Index 430-030

Straight Concrete Endwalls Single and Multiple Pipe

COMMENTS AND RESPONSES

SECTION A-A

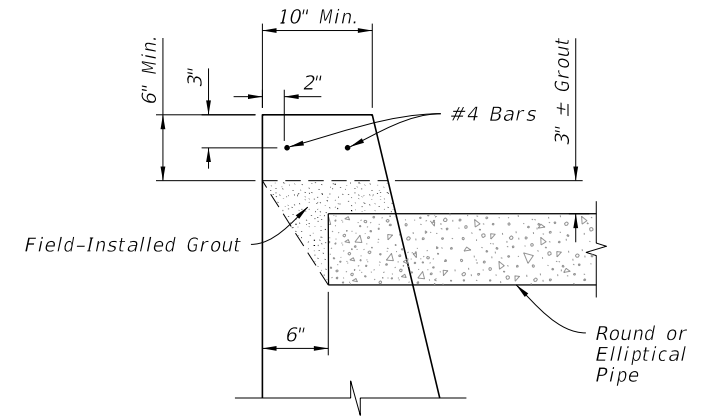
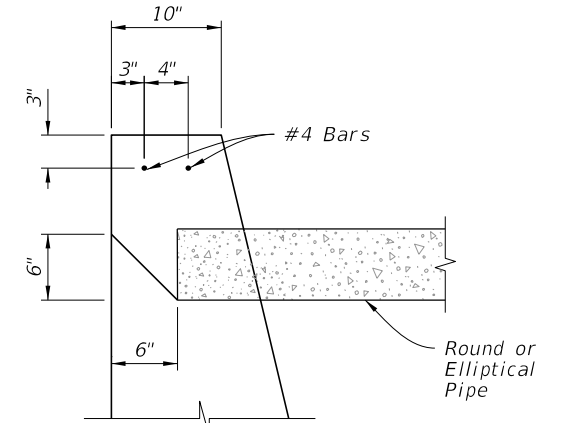
COMMENT: Good morning, we need to add the following to option #1 in reference to the fillet that joins the headwall and the pipe - "Pipe fillet installed in field by others".

COMMENT: The new option does not address the 6" of pipestop that should be included as grouted in the field in most precast endwalls. It is included in the QCP submissions that have accepted by FDOT already.

RESPONSE: Agreed. This callout will be updated to reflect that the grout is field installed.

CHANGE MADE TO INDEX: Yes. Changed "Grout" to "Field Installed Grout"

RESPONSE: Thank you for your comment. The 3" +/- callout is reflecting the OD+6" assuming a relatively centered pipe.

CHANGE MADE TO INDEX: Yes. Changed “Grout” to “Field Installed Grout”

FRONT ELEVATION

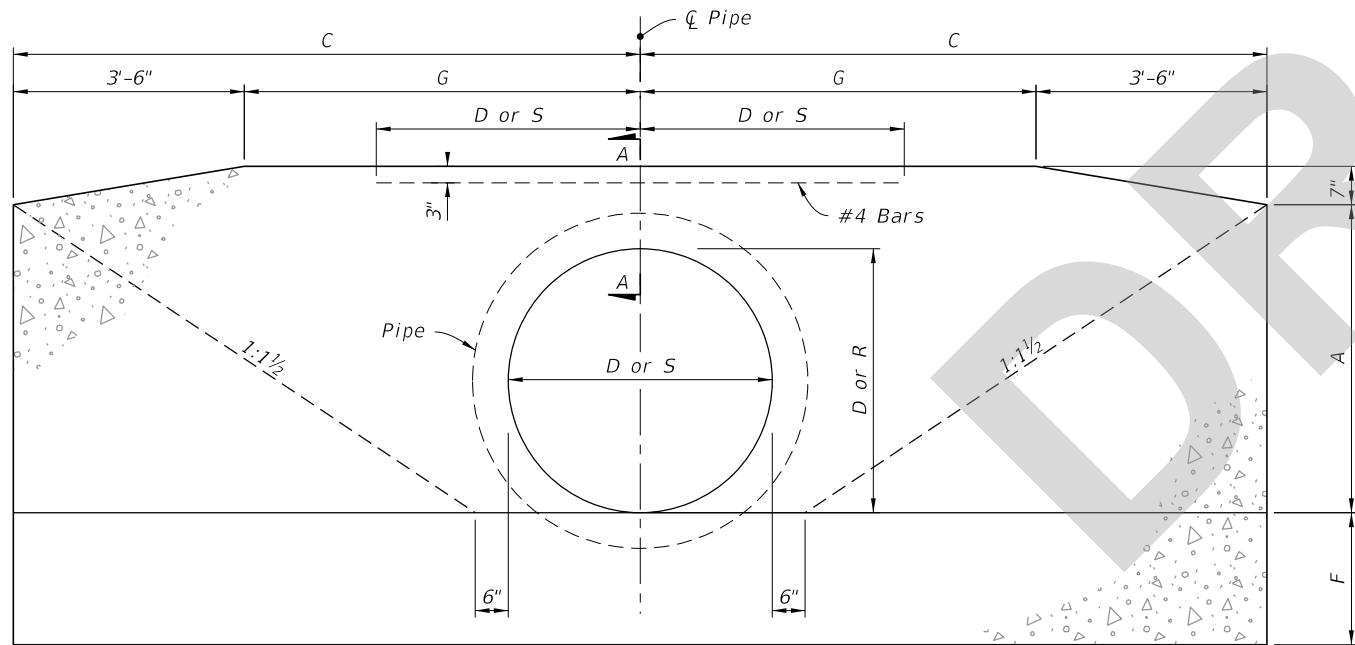
COMMENT: Please consider adding a cut section callout to the “Front Elevation” and label the new details “Section A-A” instead of Detail B for clarity of what the detail represent.

RESPONSE: Thank you for the comment. The Index will be updated to reflect the suggested changes.

CHANGE MADE TO INDEX: Yes.
